## ADDENDUM NUMBER 3

**1.01 DATE: MARCH 24, 2021**

**1.02 PROJECT: WELCOME CENTER**

**1.03 PROJECT NUMBER: DCM NO. 2020604**

**4.13 SHEET M-1.1 – MECHANICAL FLOOR PLAN – FIRST FLOOR:**

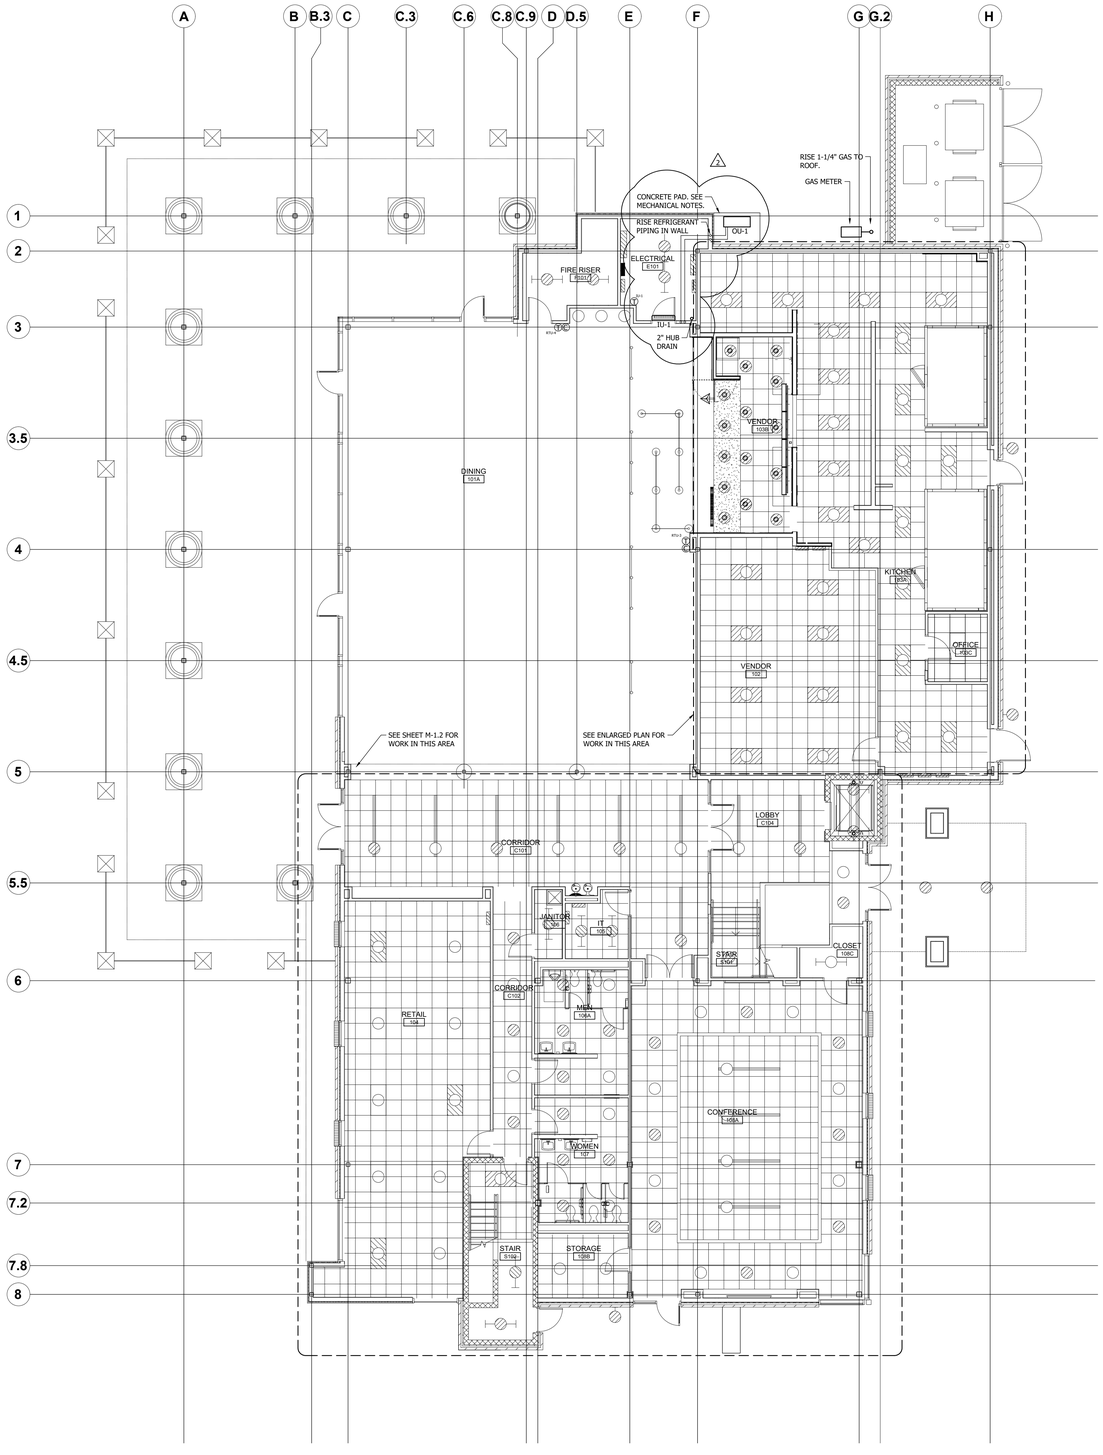
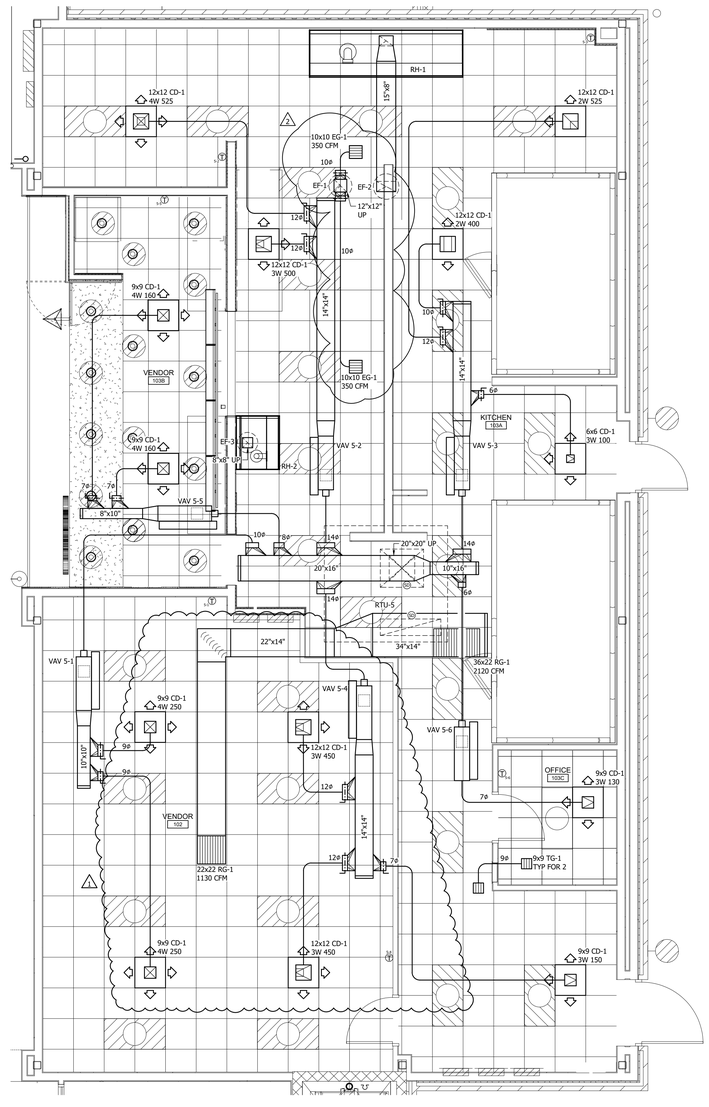
A. Replace this sheet in its entirety. Revisions include the following:
   1. Refrigerant piping has been added between the ductless split indoor unit and outdoor unit.
   2. EF-1 exhaust system has changed based on a new CFM.

**4.14 SHEET M-1.2 – MECHANICAL FLOOR PLAN – FIRST FLOOR KITCHEN:**

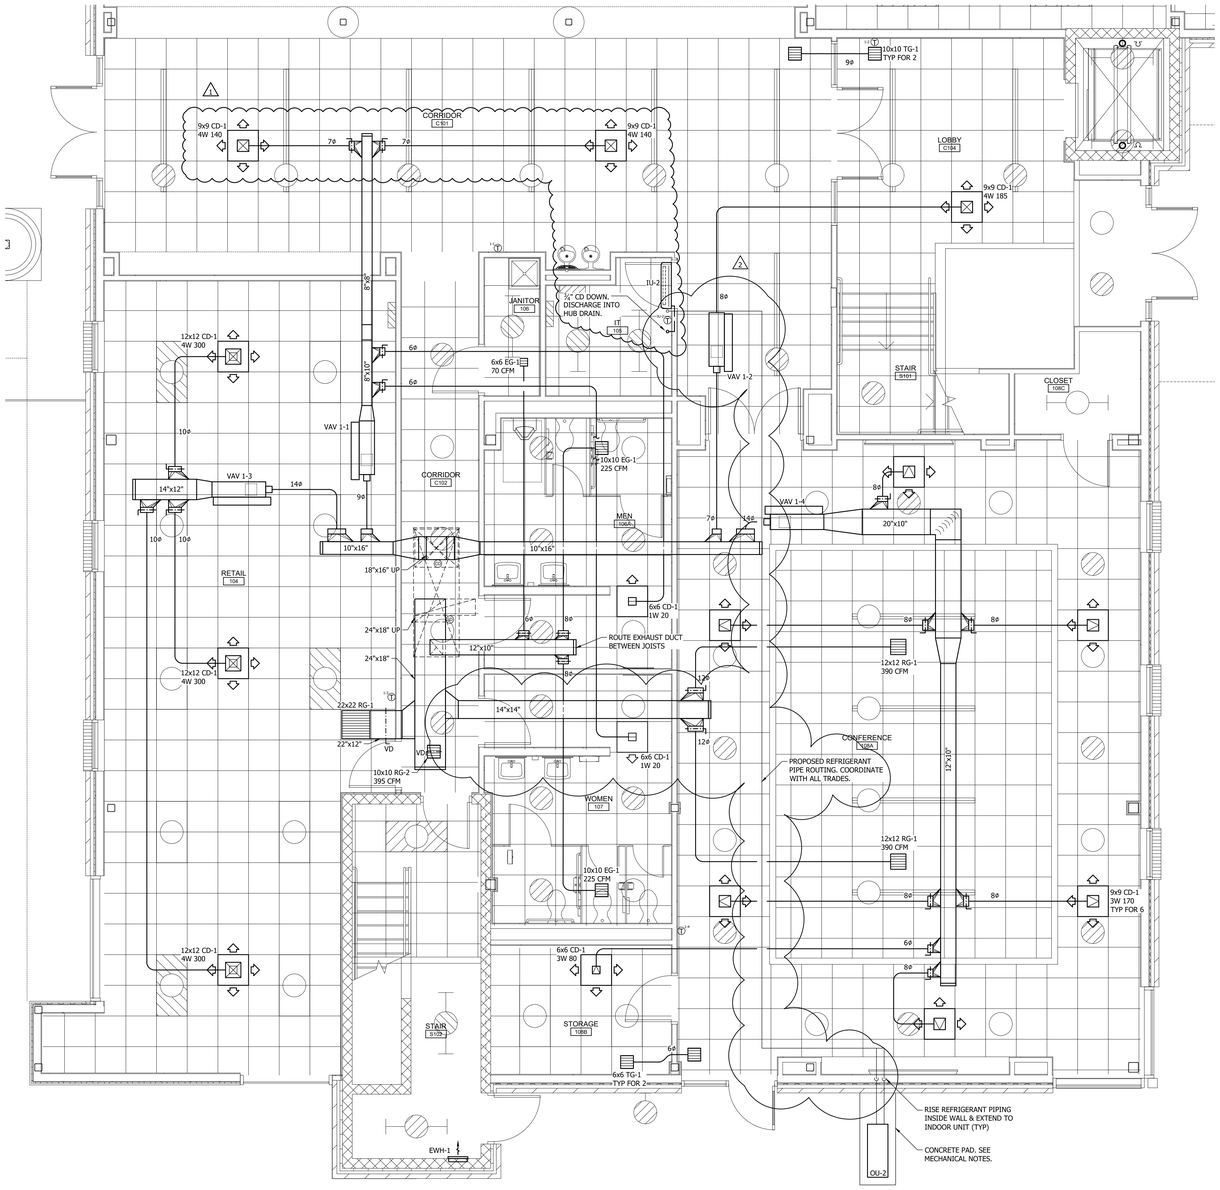
A. Replace this sheet in its entirety. Revisions include the following:
   1. Refrigerant piping has been added between the ductless split indoor unit and outdoor unit.
   2. The 14" x 14" return duct has changed position to not be over the lavatory plumbing wall.

**4.19 SHEET E-3.0 – ELECTRICAL SINGLE LINE DIAGRAM:**

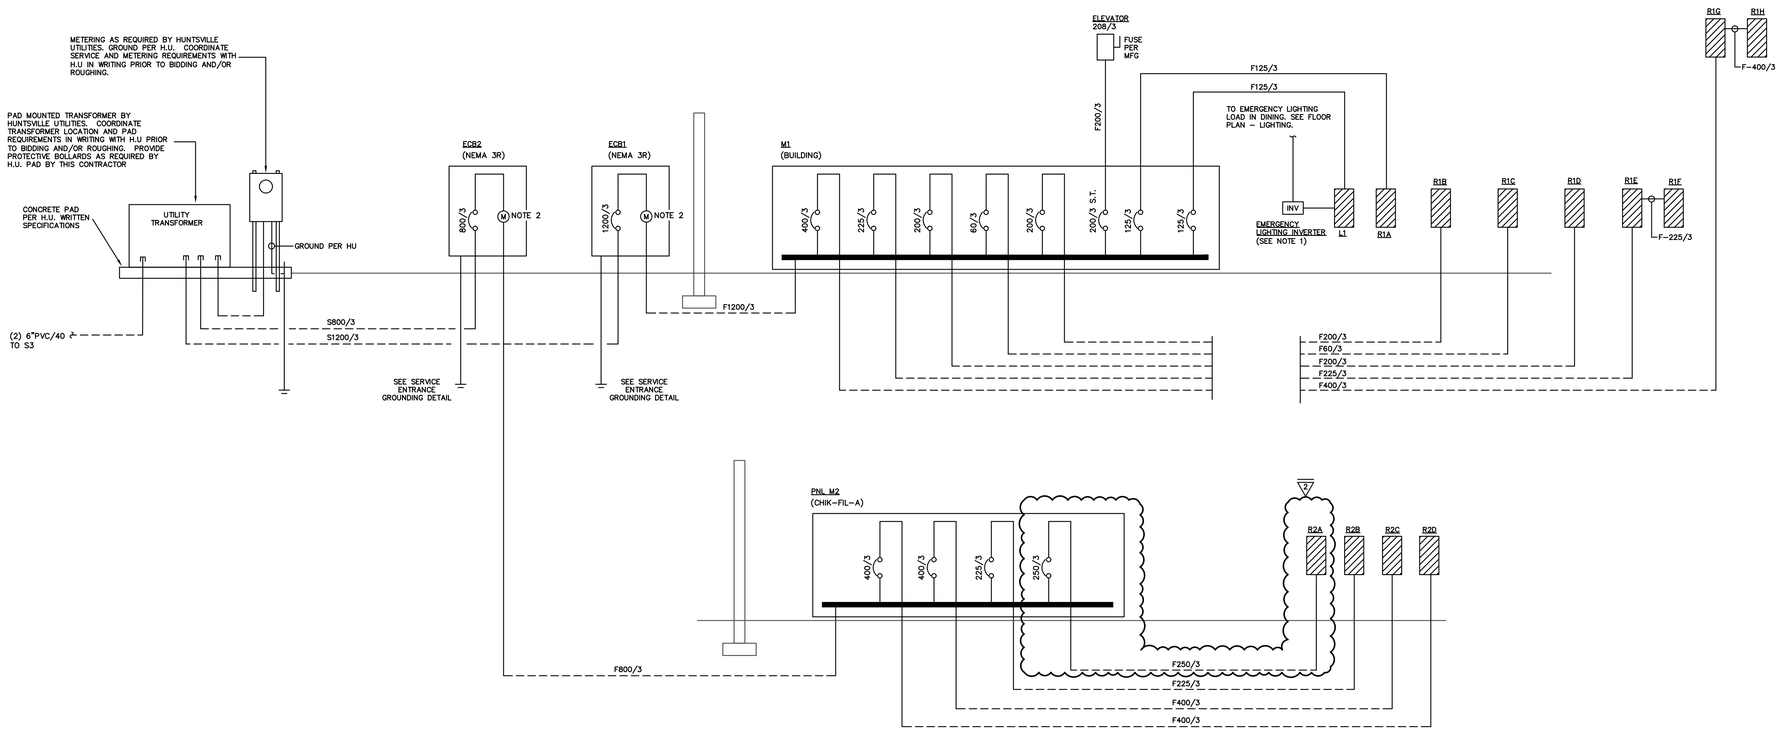
A. Replace this sheet in its entirety. Revisions include the following:
   1. Panel R2A has been added to single line.
